25 May 2026

## Minor Change to Development Approval at 52-58 Queen Street and 217-235A George Street, Brisbane City (Council Ref: A006535418)

**Figure 3** – Podium Design Comparison

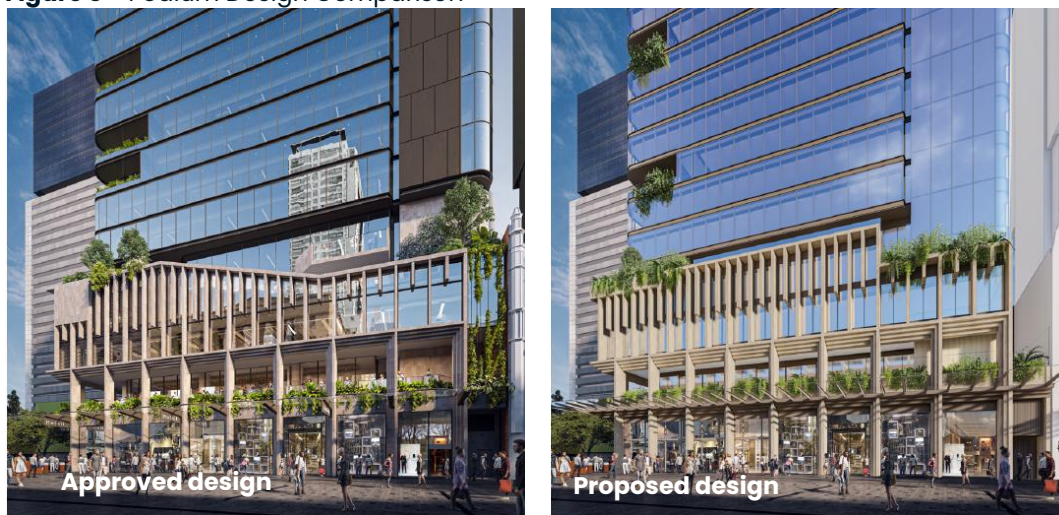
The proposal includes refinements to the podium presentation fronting Queen Street Mall, as illustrated in **Figure 4** below. These changes have occurred as part of the continued design development of the project and are intended to simplify the structural strategy, improve buildability and provide a more resolved architectural outcome.

- **Structural rationalisation and refined façade expression** – the structural strategy has been revised to simplify the podium profile from a more irregular arrangement to a clearer and more logical configuration of structural columns. This refinement improves the overall legibility of the built form while maintaining the architectural quality and presence of the podium to Queen Street Mall.

- **Minor refinements to glazing extents** – selective changes to glazing extents are proposed to support the revised structural strategy and improve the coherence of the façade composition. Importantly, the podium continues to provide a highly transparent and activated interface at the pedestrian level, maintaining strong visual connectivity between internal uses and the public realm.

- **Retention of generous ground floor presentation** – the approved generous ground floor height and open presentation are retained, continuing to support pedestrian activation, legibility and an inviting arrival experience from Queen Street Mall and Burnett Lane.

- **Continuation of approved materiality and landscaping intent** – the revised design retains the approved architectural approach of a robust masonry expression softened through integrated landscaping and greenery. This ensures the podium continues to contribute positively to the streetscape and provides a distinctive architectural outcome that complements the surrounding city context.
